# PRODUCT CHANGE NOTIFICATION

## GAS DISCHARGE TUBES

### RP2 Carrier Tape Dimension Changes for Select 3-Electrode Miniature Gas Discharge Tube Products

#### Model 2036 and 2038 Series

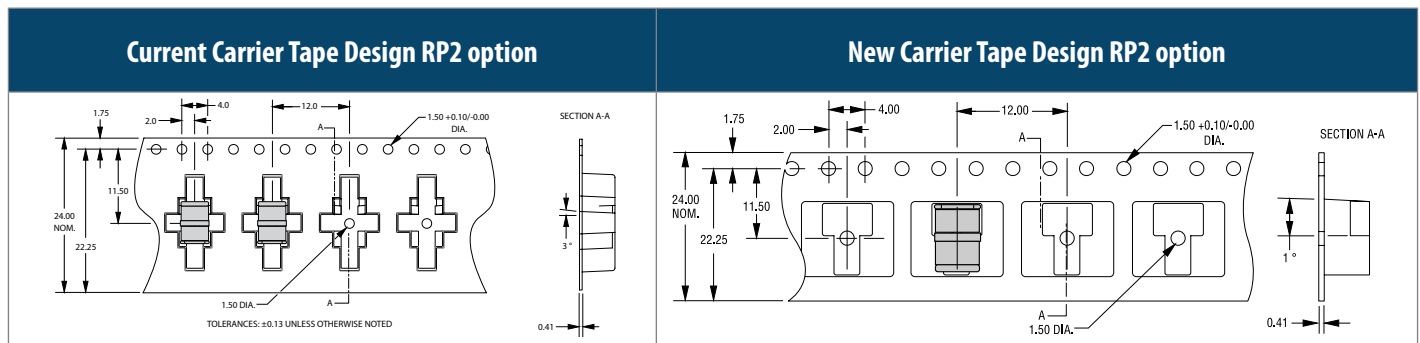
Riverside, California – February 25, 2020 – In the spirit of continuous improvement, Bourns is changing the design of the RP2 carrier tape for select Model 2036 and 2038 series 3-Electrode Miniature Gas Discharge Tubes. The carrier tape pocket design is being changed to help prevent parts from moving position during shipping. There is no change to the electrical characteristics of the products. A list of affected part numbers is included below.

These changes have no impact on the form, fit, function, quality or reliability of the affected products. The product marking and label will remain unchanged. The carrier tape dimension changes will affect the fit and form of the packaging as shown.
